### Remarks

### **Amendments to the Drawings**

The attached sheets of drawings include changes to FIGs. 6B, 7A, 7B, 7C and 8B. Sheet 5 / 20, which includes FIGs. 6A and 6B, replaces original sheet 5 / 20 including FIGs. 6A and 6B; sheet 6 / 20, which includes FIGs. 7A and 7B, replaces original sheet 6 / 20, including FIGs. 7A and 7B; sheet 7 / 20, which includes FIG. 7C, replaces original sheet 7 / 20, including FIG. 7C; sheet 8 / 20, which includes FIGs. 8A, 8B and 8C, replaces original sheet 8 / 20, which includes FIGs. 8A, 8B and 8C. In FIG. 6B previously omitted reference numerals **406** and **407** (2 instances) are added. In FIG. 7A, 7B and 7C, the lead line running from reference numeral **315** is repositioned. In FIG. 8B reference numerals **304**, **305** (2 instances) and **306** (two instances) replace erroneous instances of reference numerals **354**, **355** and **356**, respectively.

Fig. 6B

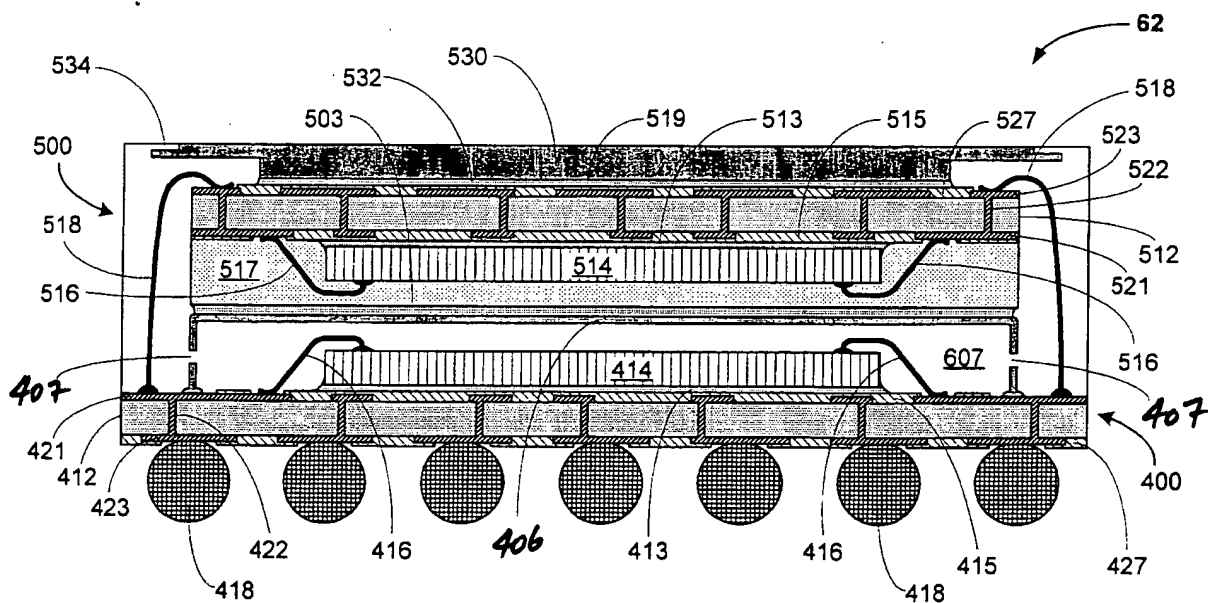
The drawings were objected to under 37 CFR 1.84(p)(5), the Examiner asserting that “they include the following reference characters not mentioned in the description: 11, 43, 47, 50, 52, 86, 90, 92, 142, 305, 306, 313, 818”, and noting further that “Fig. 6B has two lines that are not represented by references numerals.” The Examiner required correction of the drawings, or amendment of the specification.

As to the objection to Fig. **6B**, Fig. **6B** is amended herein by insertion of missing reference numeral **406**, and **407** (2 instances), to be consistent with the description and with the reference numeration of Fig. **6A**, and this objection can now be withdrawn.

Fig. 7A

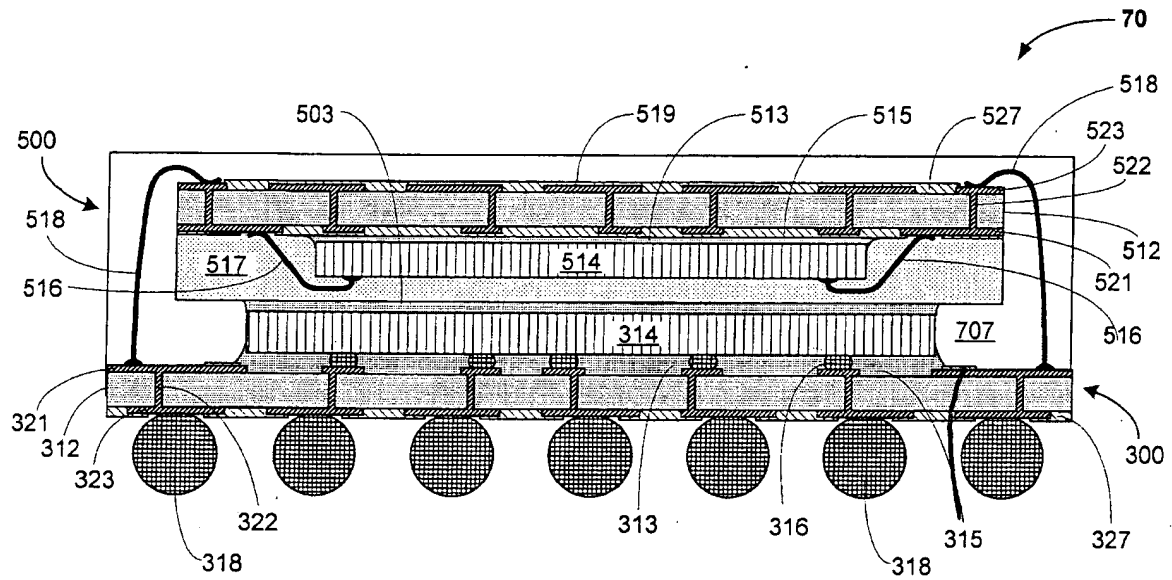
In Figs. **7A, 7B** and **7C**, the lead line from reference numeral **315** is moved, to indicate the “solder mask”, *see* paragraph **[00140]**. It is noted that reference numeral **313** indicates the underfill, *see* paragraph **[00136]**.

Fig. 8B

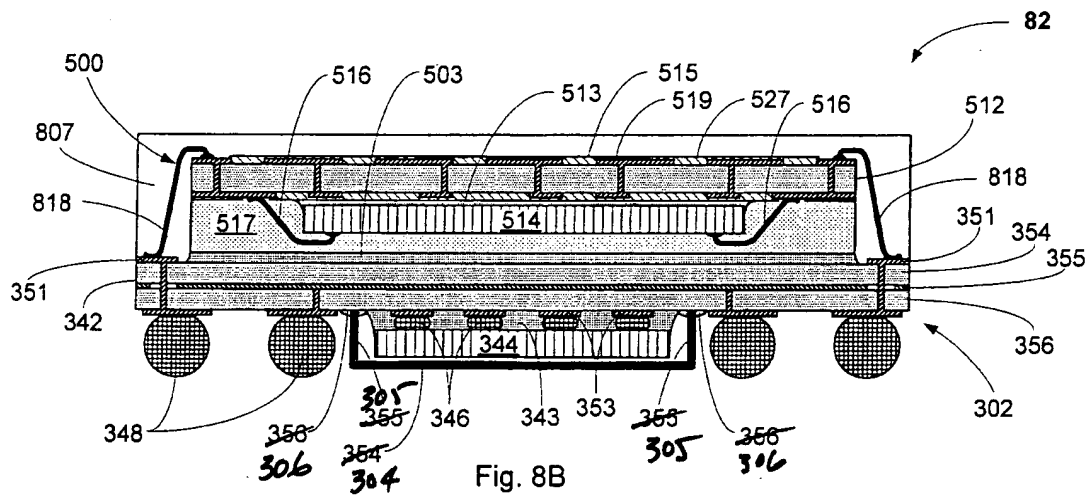
- **90, 92** -- is inserted following “embodiments of the invention” in paragraph **[00180]**;
- “**355**” is replaced with -- **305** --, “**356**” is replaced with -- **306** --, and “**354**” is replaced with -- **304** -- (paragraph **[00165]**) to make the text consistent with the reference numeration of FIG. **8C** and to avoid use of any reference numeral to identify more than one feature. It is noted that metal layer **355** is sandwiched between dielectric layers **354, 356** in bottom package substrate **342** (*see, e.g.*, paragraph **[00157]**, Figs. **8A, 8B, 8C**). Accordingly, Fig. **8B** is amended to make the reference numeration consistent with that of Fig. **8C**, by replacing the instances of reference numerals **354, 355, 356** that are directed to the lower planar part and the legs or sidewalls of the heat spreader, and the adhesive by which the heat spreader is affixed to the substrate, with, respectively, numerals **304, 305, 306**;
